Tennessee Valley Authority, 1101 Market Street, Chattanooga, TN 37402

CNL-16-184

Subject: Submittal of Additional Supplemental Information Related to Stability of
Subsurface Materials and Foundation in Support of Early Site Permit Application
for Clinch River Nuclear Site

ADDITIONAL SUPPLEMENTAL INFORMATION RELATED TO STABILITY OF SUBSURFACE MATERIALS AND FOUNDATION OF THE EARLY SITE PERMIT APPLICATION FOR CLINCH RIVER NUCLEAR SITE

Figure 2.5.1-51. Cross-Section Distribution of Cavities in Rock Core

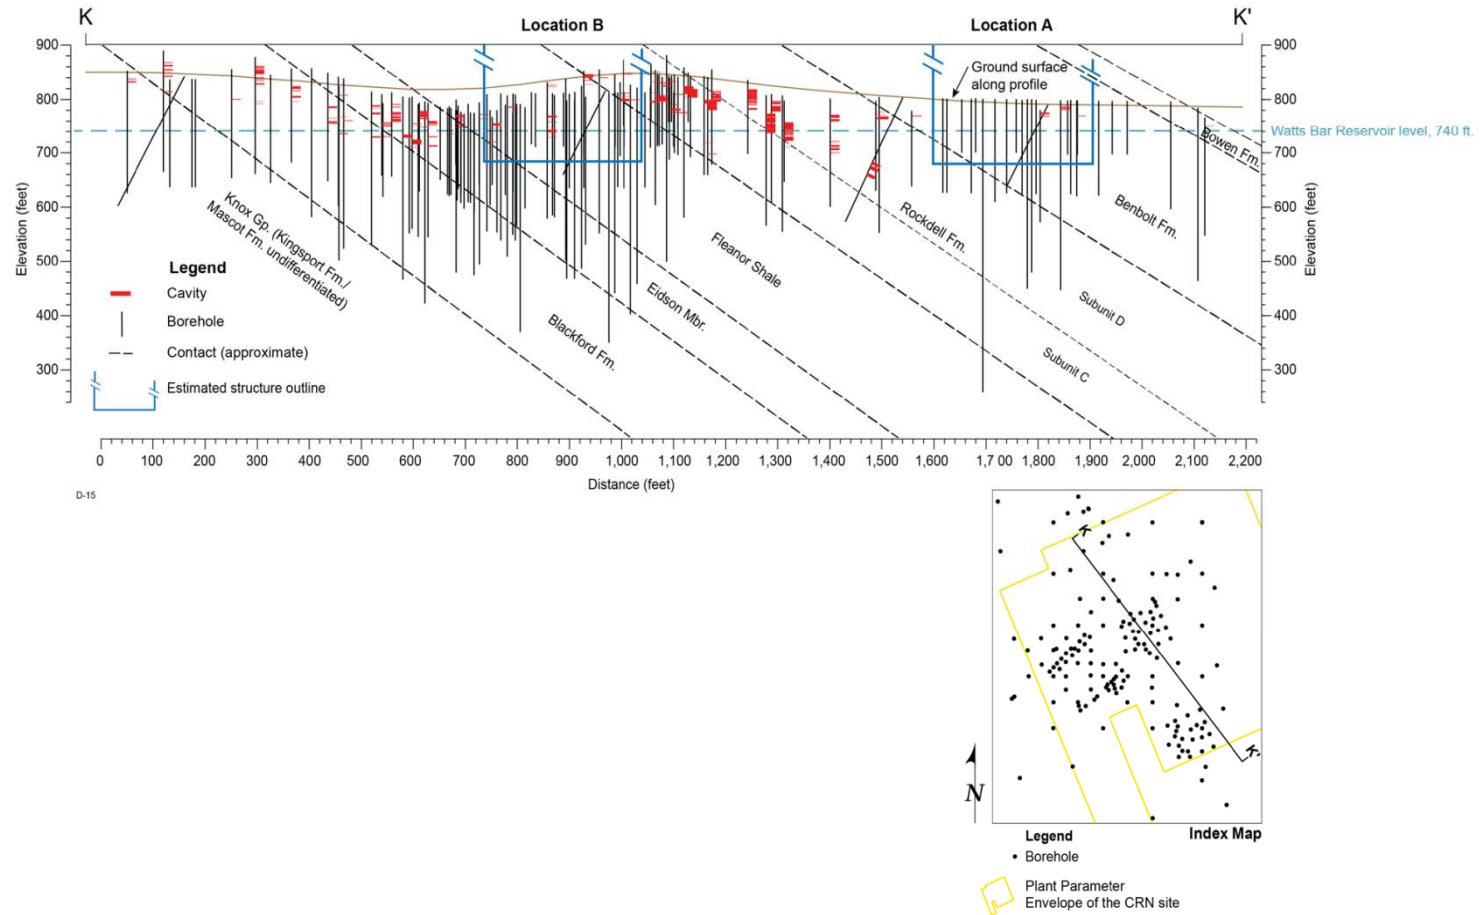
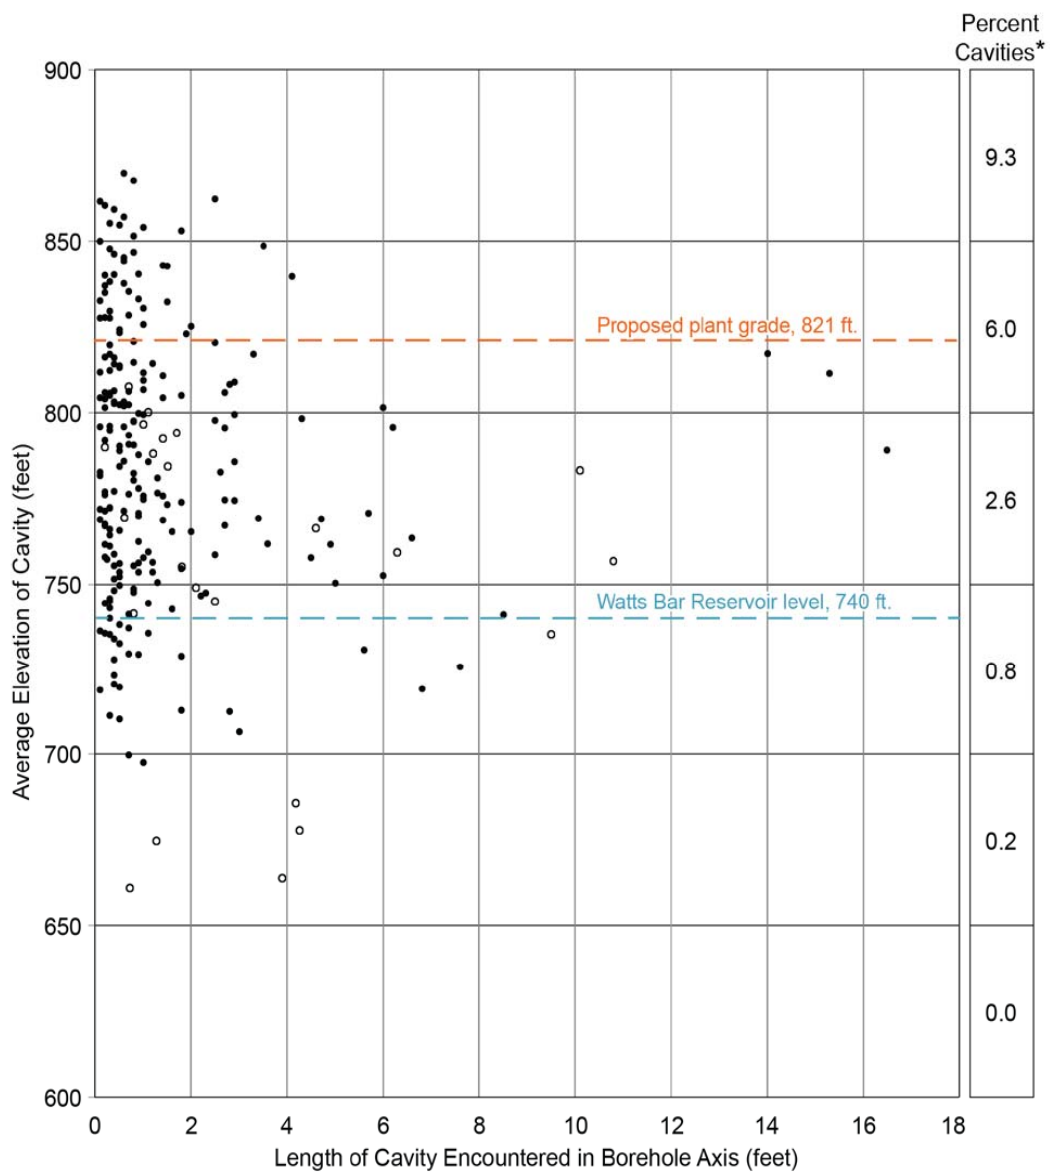
As a result of the new Subsection 2.5.1.2.9, the following existing figures are being revised and replaced.

- (1) Boreholes are projected on to a vertical plane oriented perpendicular to bedding strike of N52°E
- (2) Borehole data are compiled from the CRBRP (Reference 2.5.1-100) and the CRN investigation (Reference 2.5.1-214)
